HOME BUILDERS
ASSOCIATION
of
METRO DENVER®

05/28/2019

ERIE JTF Meeting

Working Group Comments 09/24/19

10.6.3 Parks, Open Space and Trails

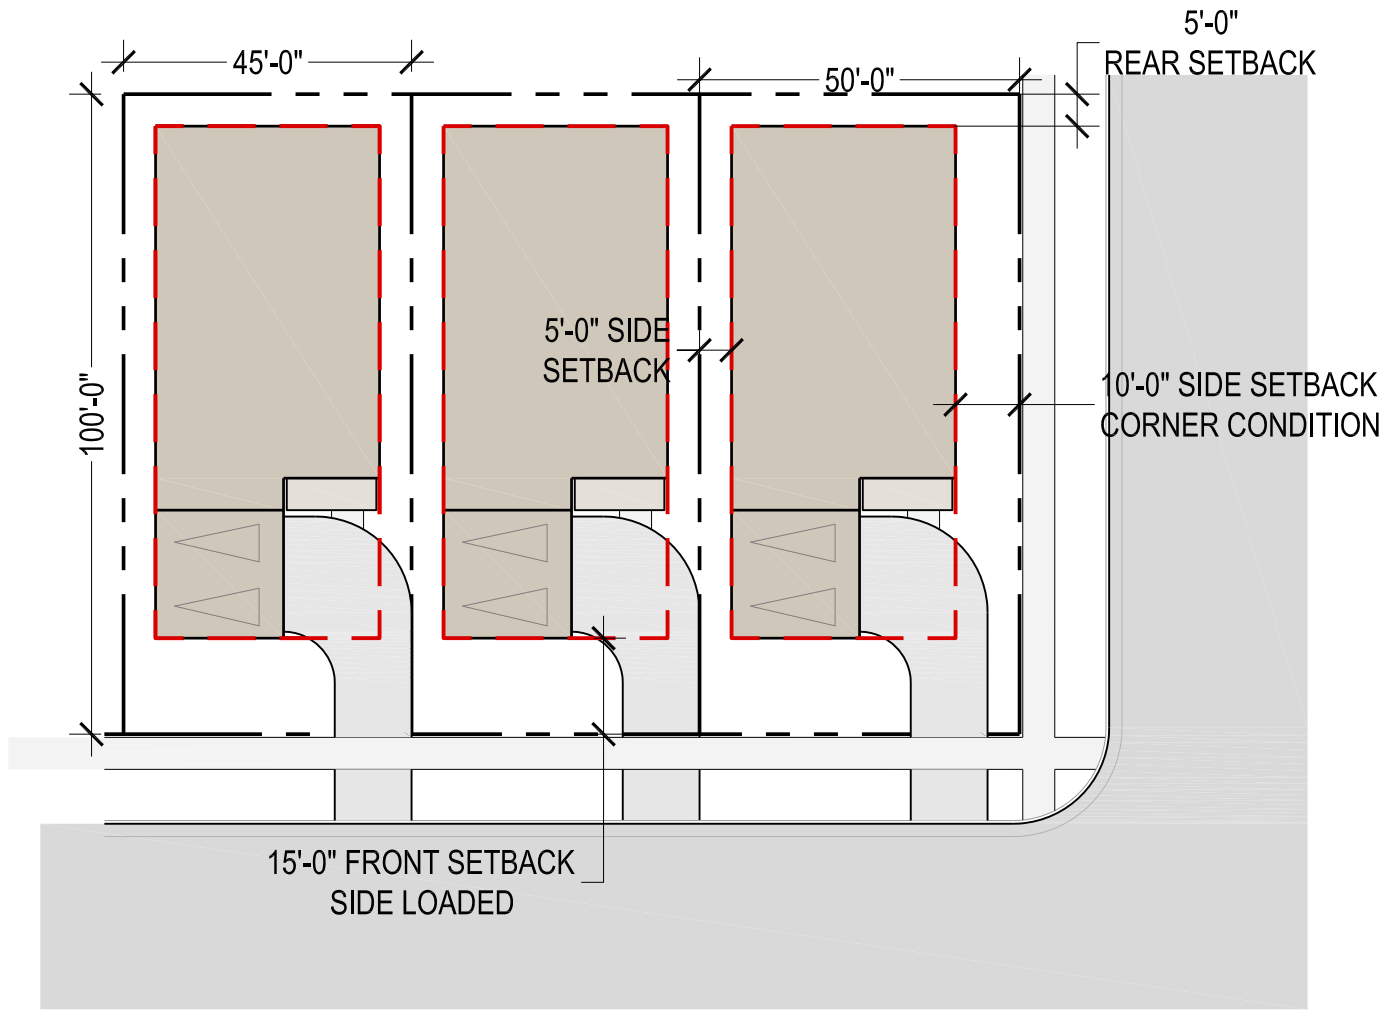
Discussion Points (If parks and recreation staff is not at September meeting, can move this to October after initial discussion)

- We propose that Erie consider adjusting the number of residents per home multiplier based on residential product type or density. Considerations:
 - Net Dwelling units per acre
 - Bedroom count
 - Single vs. Multi-Family
 - Senior-Living

- Other ideas?
- Parks and Open Space Requirements
 - Land Dedication – to city OR metro district?
 - Neighborhood Park minimums
 - Credit towards neighborhood park requirement
 - Consider adjusting minimums for flexibility
